FINAL ENVIRONMENTAL IMPACT REPORT

**EIR No. 96-0090-SUB(ZV)(CUB)(DA)
STATE CLEARINGHOUSE No. 96051050**

Vesting Tentative Tract No. 52172

HARBOR GATEWAY CENTER

**Figure 7
Conceptual Area 1
Site Plan**

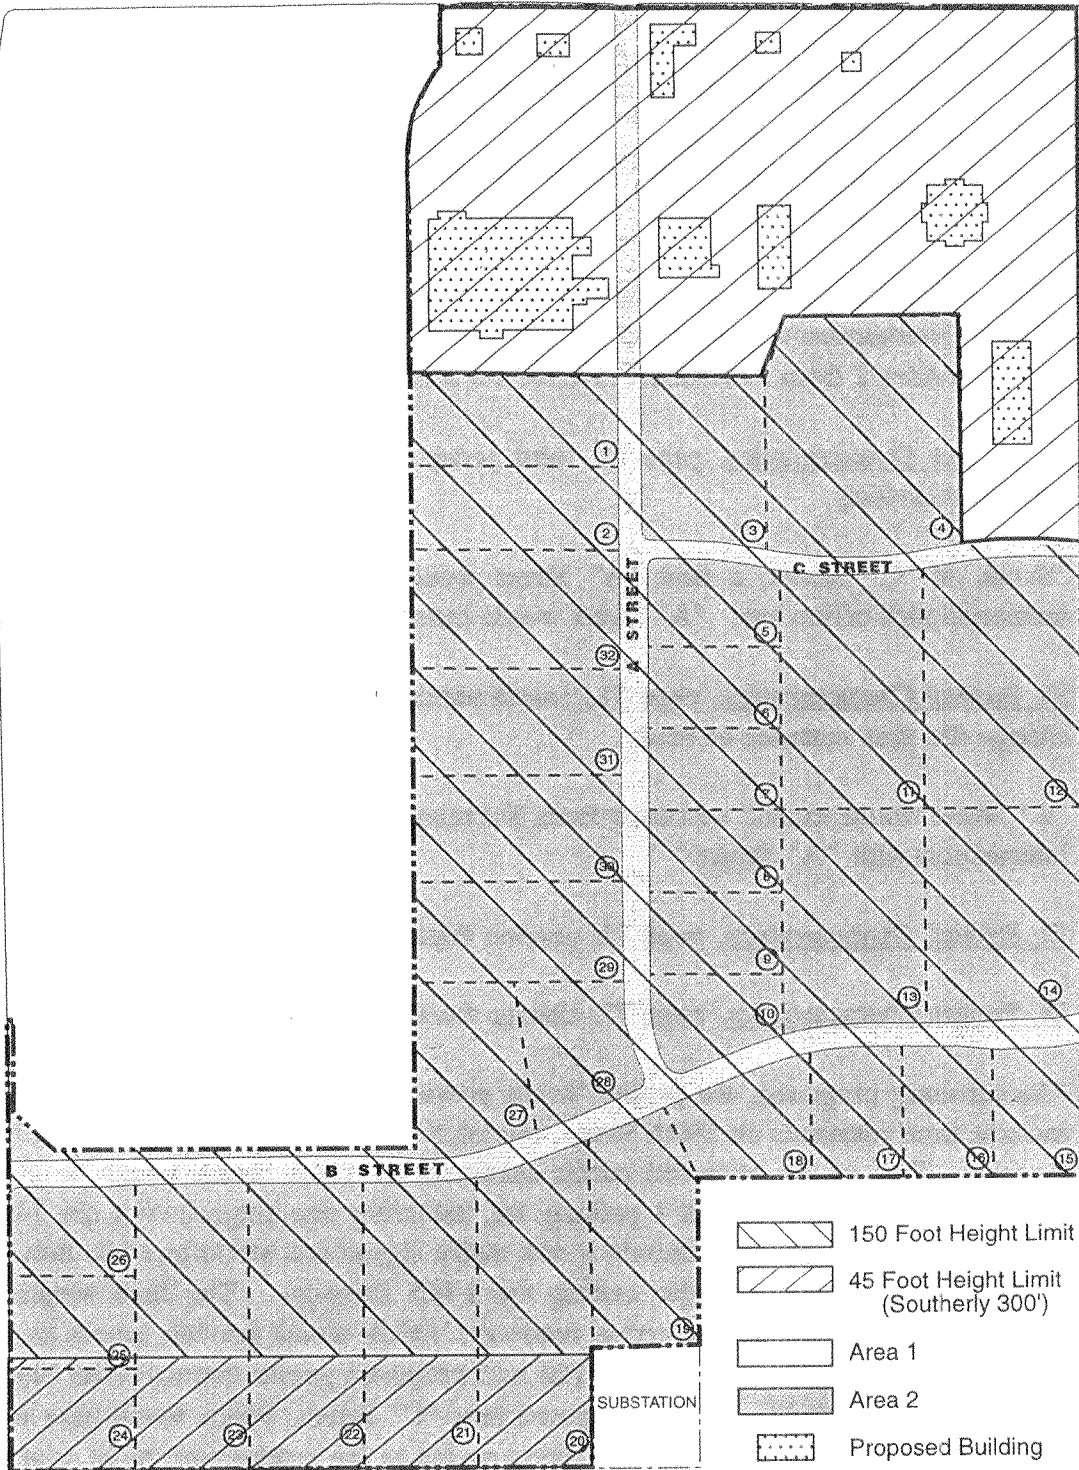
"Represents an approximately 0.25:1 FAR."
- l. D. Project Characteristics, page 66, first paragraph, fourth sentence, change "0.26:1" to "0.25:1".
- m. D. Project Characteristics, page 67, revise Figure 7 as shown on page 58.
- n. D. Project Characteristics, page 69, revise Figure 8 as shown on page 59.
- o. D. Project Characteristics, page 71, change the second paragraph under **a. Vehicular Circulation**, to read:

**Figure 10
Internal Circulation System**

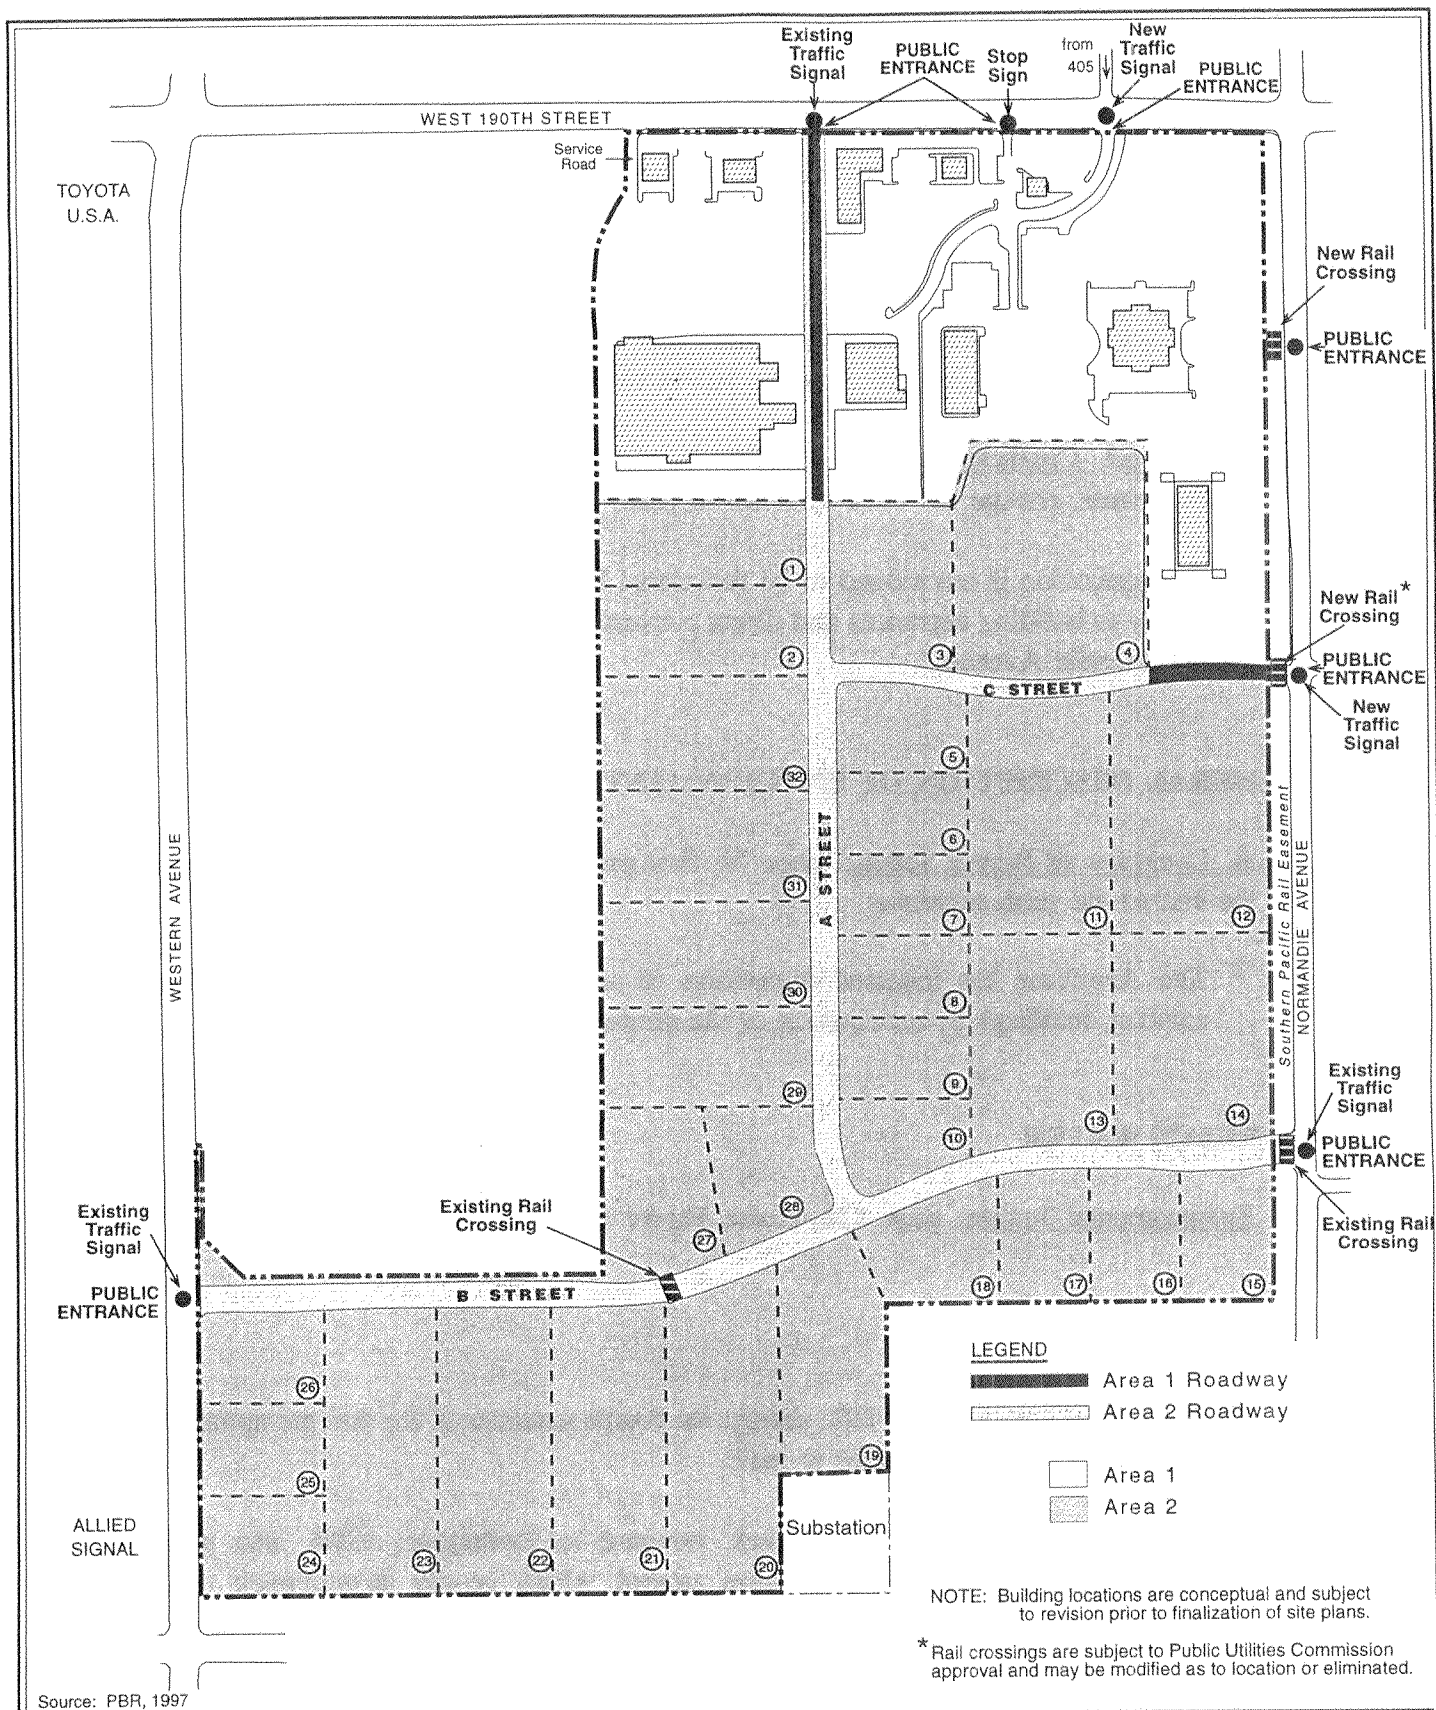
- s. D. Project Characteristics, page 72, revised Figure 10 as shown on page 61.

"South of "C" Street, a new "A" Street would be constructed to serve proposed industrial park/office lots. "A" Street would extend south to intersect with "B" Street."

"C" Street would extend westward from Normandie Avenue and would terminate at its intersection with "A" Street."

"As currently proposed, the project would provide six public entrances. These would include three entrances on 190th Street, two on Normandie Avenue, and one on Western Avenue. Two of the proposed public entrances on 190th Street would be driveways providing access to the Area 1 parking lot, including one aligned with the I-405 off-ramp, which is proposed to include a new traffic signal and would provide direct access to the retail center for traffic exiting the I-405 freeway. The third would be the proposed north-south ingress-egress roadway, which would provide access to Area 2, as well as serving the retail area. The two proposed public entrances on Normandie Avenue would include: (1) the proposed new "C" Street, which would also include a new rail crossing and would provide direct access to the eastern portion of Area 1 when the retail component of the project is built and would be extended to provide direct access to Area 2 when the industrial/office park component of the project is built; and

Figure 14
Existing and Proposed
Storm Drains

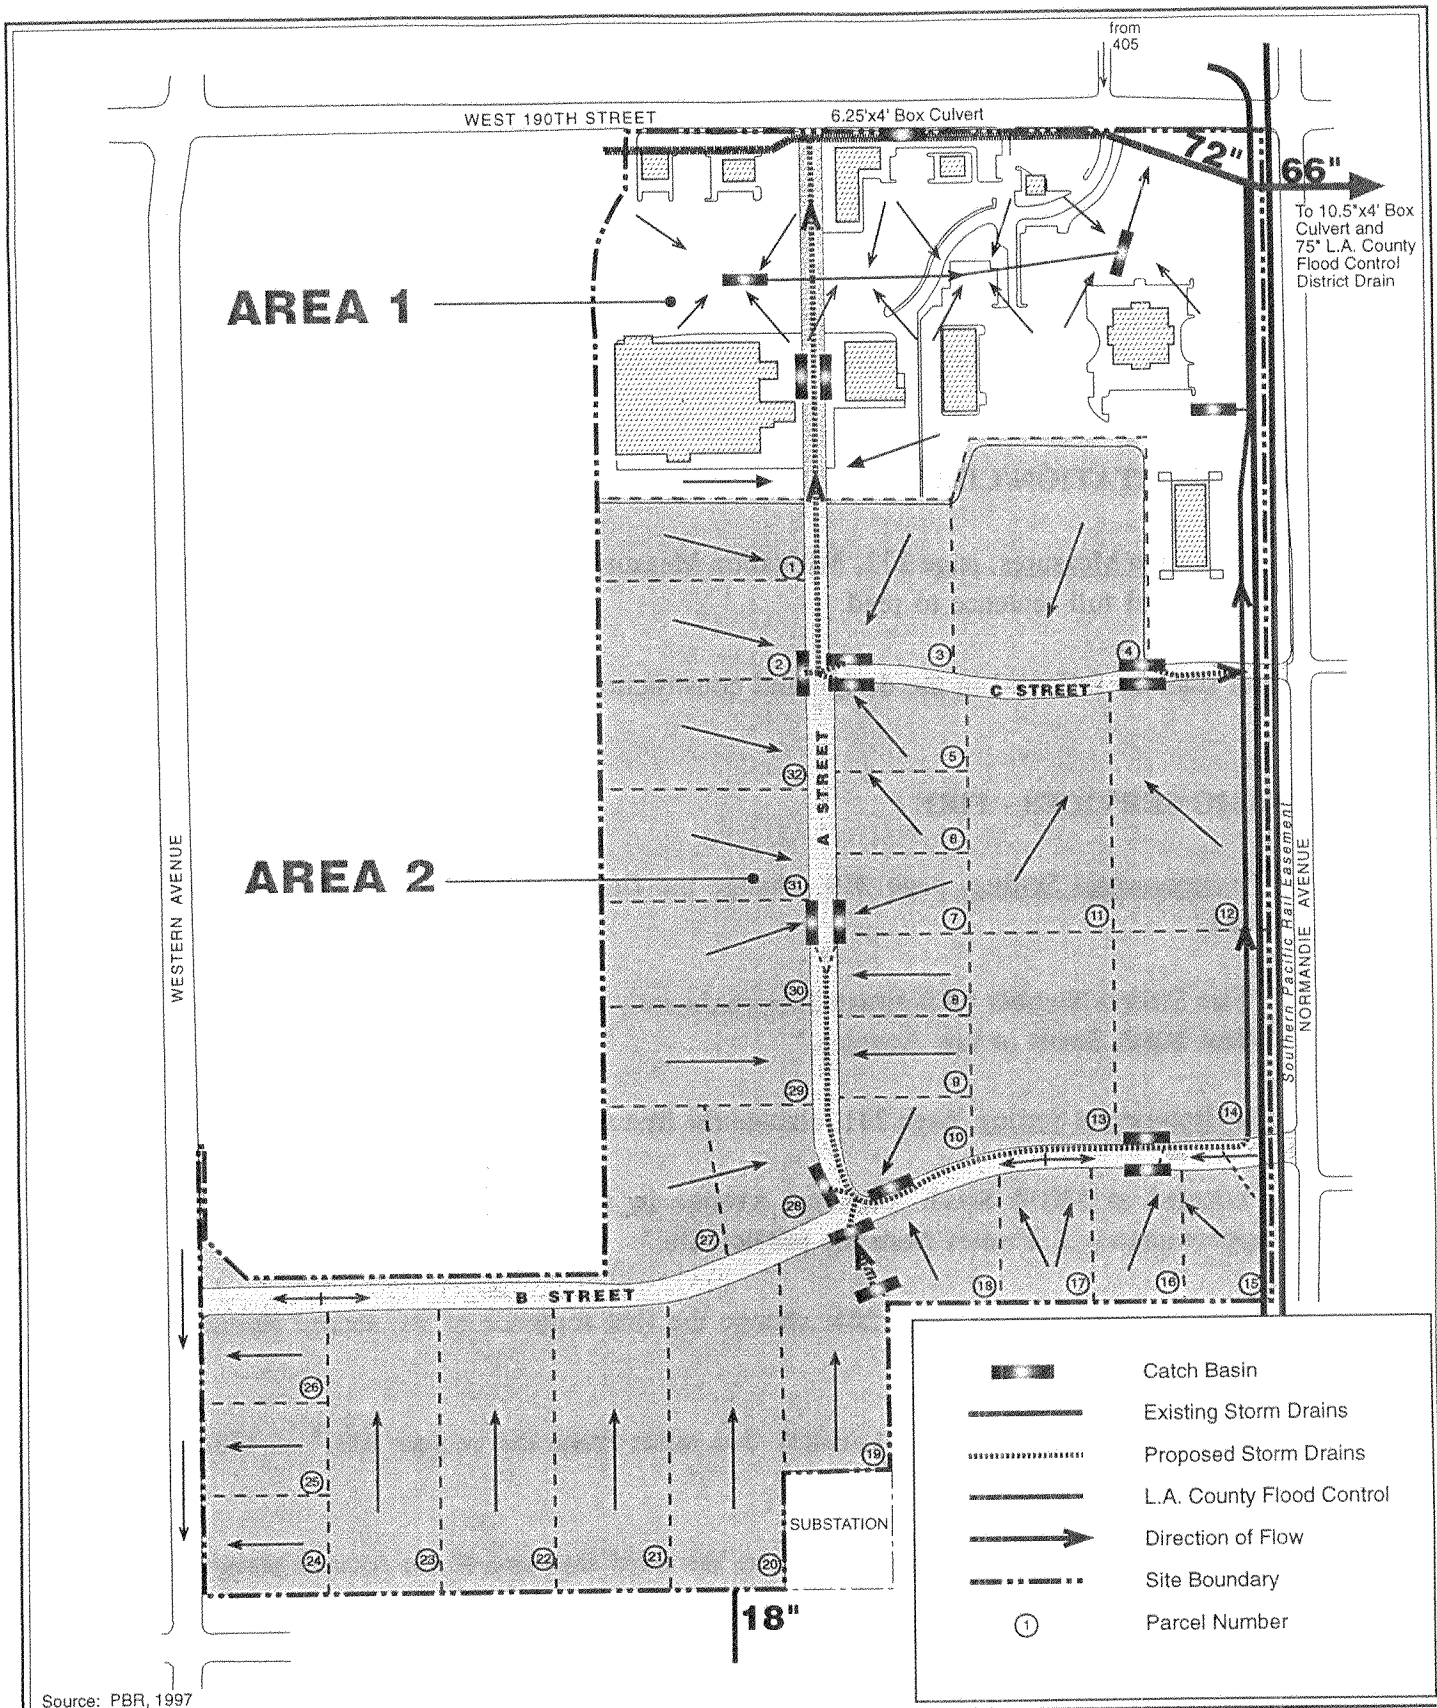
- a. Environmental Setting, page 126, revise Figure 14 as shown on page 63.

Figure 30
**Existing and Proposed
Water System**

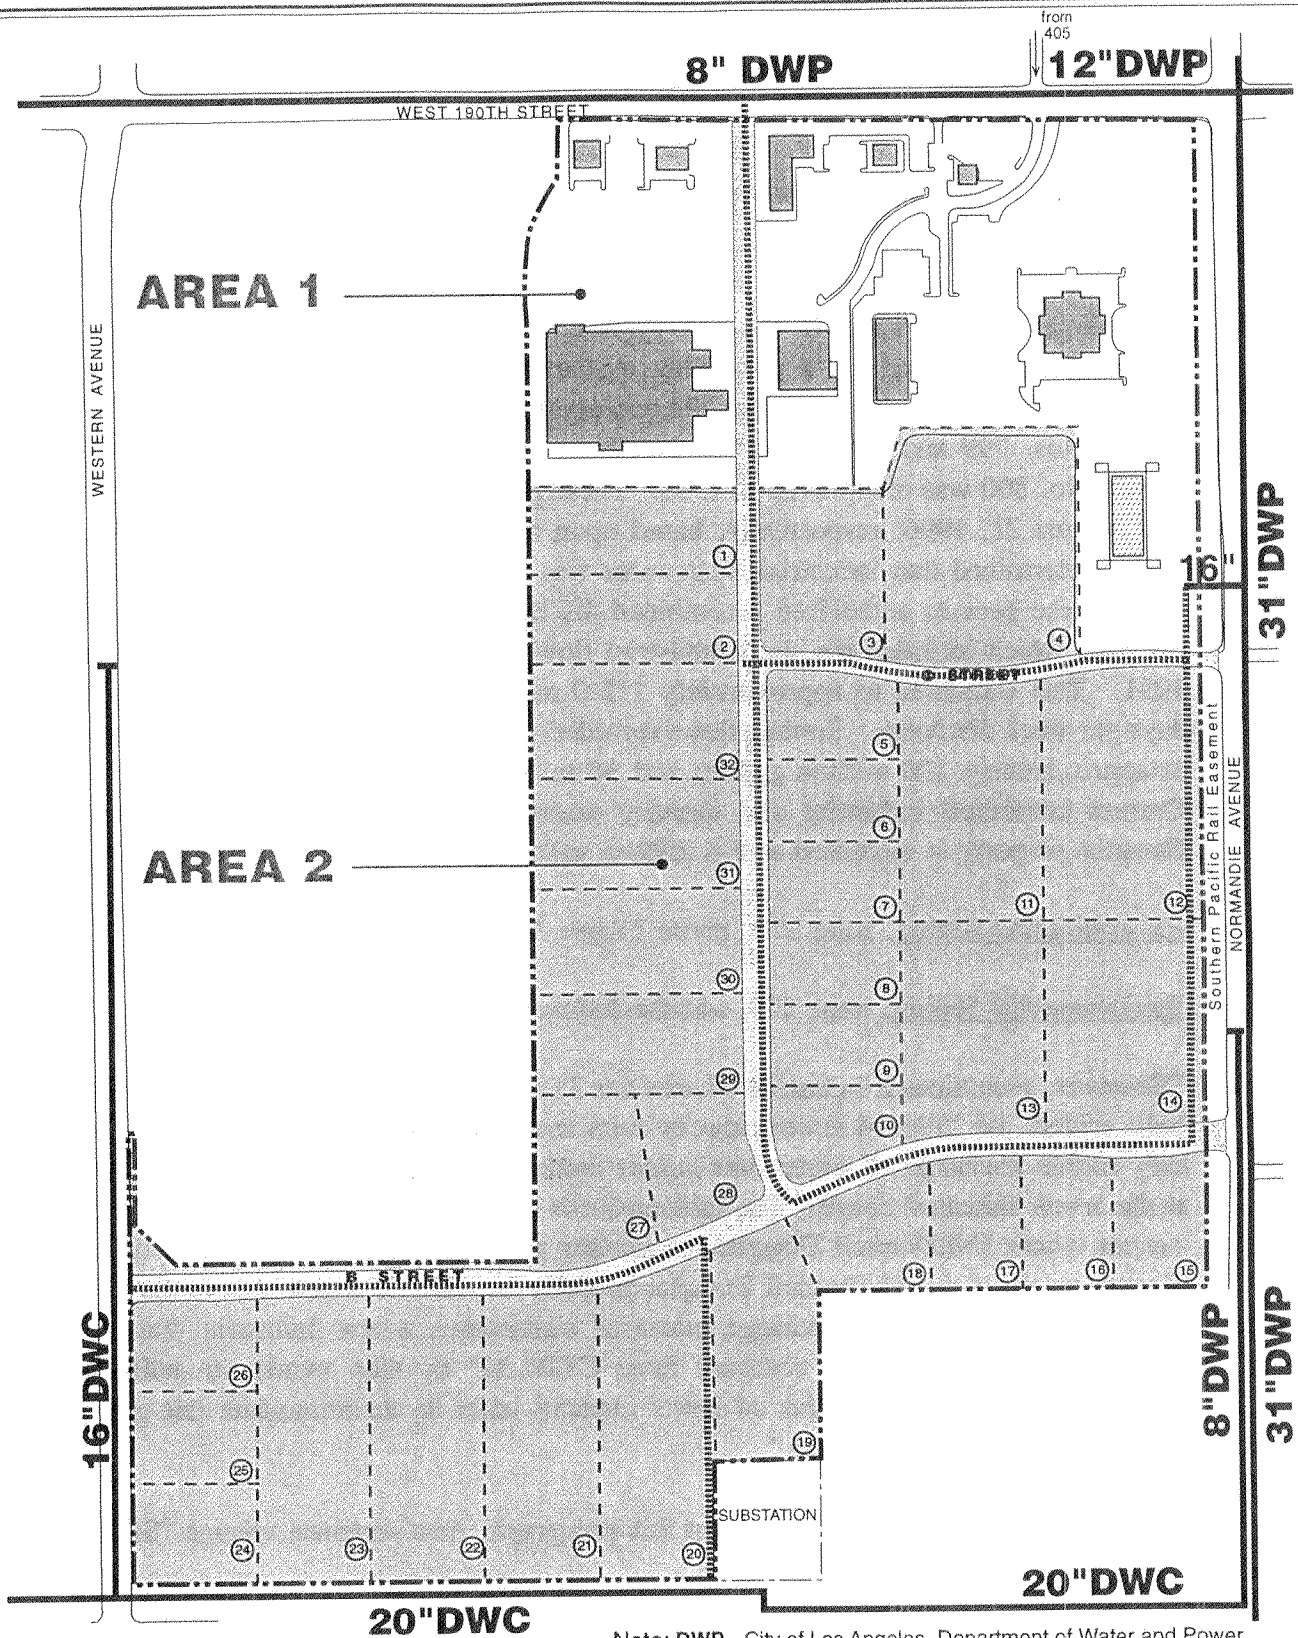
- a. Environmental Setting, page 271, revise Figure 30 as shown on page 69.
- b. Project Impacts, page 272, change the fourth sentence of the second full paragraph to read:

New water lines would connect to both the 8 to 12-inch DWP line in 190th Street and the existing 16-inch line located on-site which ties to the 31-inch DWP line in Normandie Avenue.

Because the two main water mains in 190th Street and Normandie Avenue to which the new system will connect are in different pressure systems, pressure regulation will be necessary to serve the site.

**Figure 31
Existing and Proposed
Sewer System**

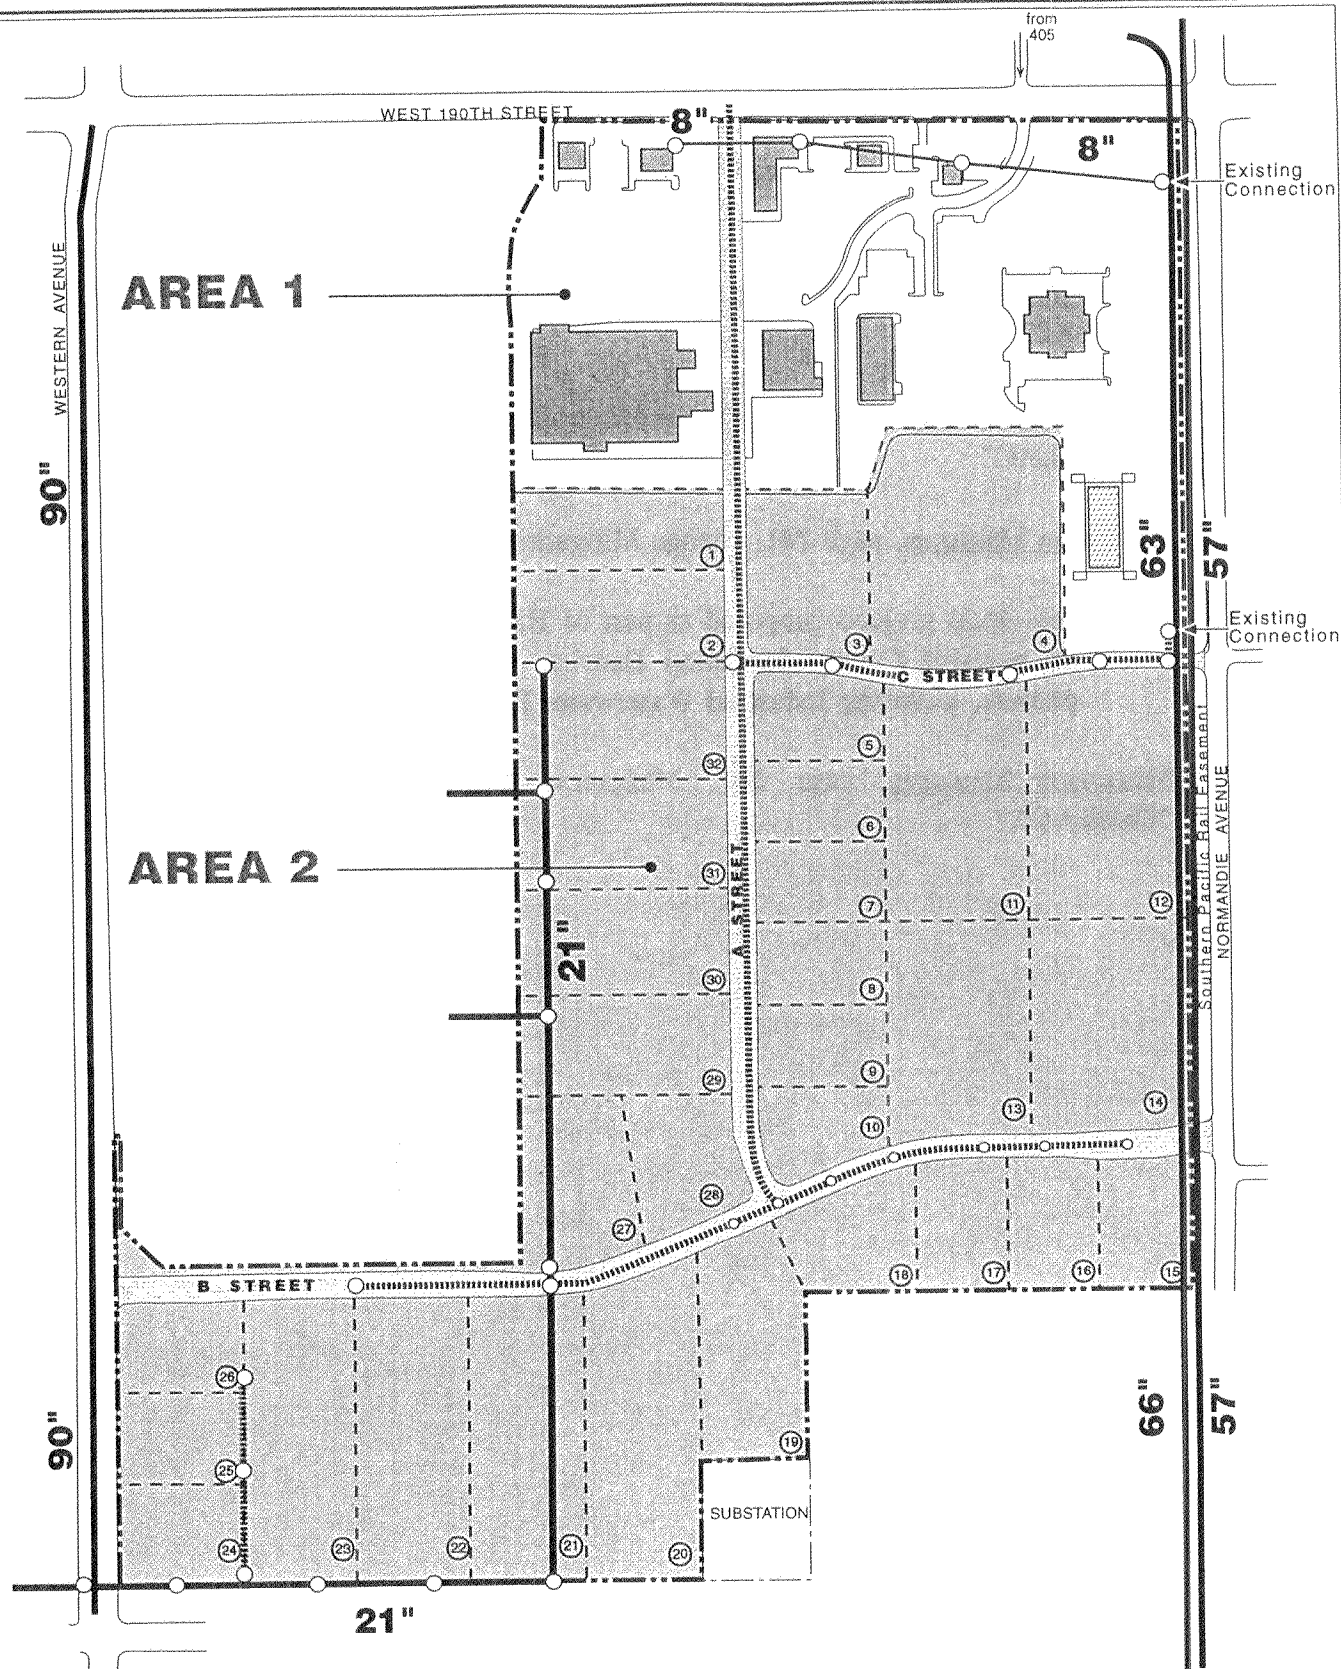
- c. Environmental Setting, page 278, revise Figure 31 as shown on page 71.
- d. Environmental Setting, page 279, add the following after the first (partial) paragraph:
